Access Compliance Report

Public Rights-of-Way

Intersection ID: N/A	Main Street: SOUTHSTREAM_BV	Cross Street: N/A	Location: NE
ADA ID: CE05C722A707	Ramp Type: PerpDiag	Initial Pass/Fail: Fail	Overall Compliance: No
Codes/Mitigation Info/Possible Solution		Field Measurements/Component Compliance

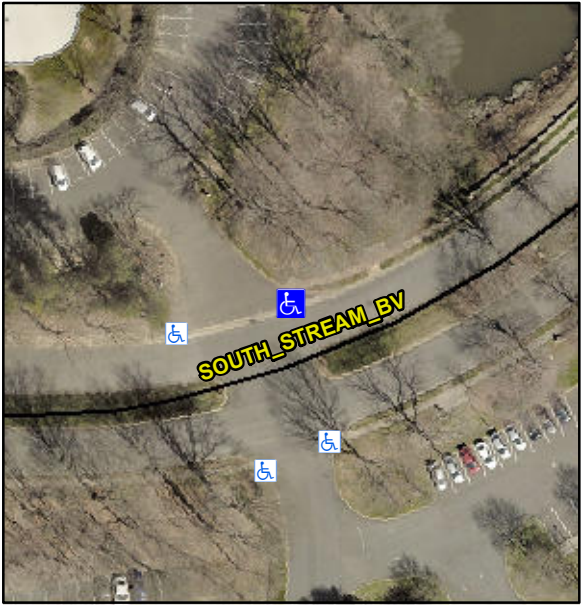
Possible Solutions:	Compliance	Description	Data	Compliance	Description	Data
	Remove & Replace Curb Ramp With Two New Directional Ramps or Equivalent.	N/A	Ramp Length (in)	65.0	No	Ramp Slope (%)	10.5
		Yes	Ramp Width (in)	65.0	No	Ramp XSlope (%)	4.5
		N/A	Flare Type LT	N/A	N/A	Flare Type RT	N/A
		N/A	Flare Slope LT (%)	N/A	N/A	Flare Slope RT (%)	N/A
		N/A	Flare Traversable LT?	No	N/A	Flare Traversable RT?	No
		N/A	Landing Length (in)	N/A	N/A	DWS Provided?	N/A
		N/A	Landing Width (in)	N/A	N/A	DWS Contrast?	N/A
		N/A	Landing Slope (%)	N/A	N/A	DWS Length (in)	N/A
		N/A	Landing X Slope (%)	N/A	N/A	DWS Full Width?	N/A
		N/A	Landing Curb? (Y/N)	N/A	N/A	DWS Offset (in)	N/A
		N/A	Shared Landing?	N/A			
		N/A	Gutter Ponding?	N/A	N/A	Gutter Slope (%)	N/A
		N/A	Gutter Lip Ht (in)	N/A	N/A	Gutter X Slope (%)	N/A
		N/A	Painted X Walk1?	No	N/A	Painted X Walk2?	No
			X Walk 1 Direction	To W		X Walk 2 Direction	To S
		N/A	X Walk 1 Width (in)	N/A	N/A	X Walk 2 Width (in)	N/A

X Walk 1 Slope (%)	6.4		X Walk 2 Slope (%)	1.8
			X Walk 1 X Slope (%)	3.1		X Walk 2 X Slope (%)	10.0
		N/A	Ramp inside XWalk1?	N/A	N/A	Ramp inside XWalk2?	N/A
<p>Surveyor Notes:</p> <p>N/A</p> <p>PROW/ADA:</p> <p>R304.2.2, R304.5.3</p>			Road Slope (%)	5.9	N/A	Clear Space?	N/A
			Road X Slope (%)	6.6	N/A	Clear Space to XWalk (in)	N/A
<p>Total Cost:</p> <p>\$ 3200.00</p>		N/A	Any Obstructions?	N/A	N/A	Storm Grate/Utility Hazard?	N/A
			Obstruction Type			Storm Grate/Utility Type	
				N/A			N/A
					Yes	Surface Condition? (G/P)	Good
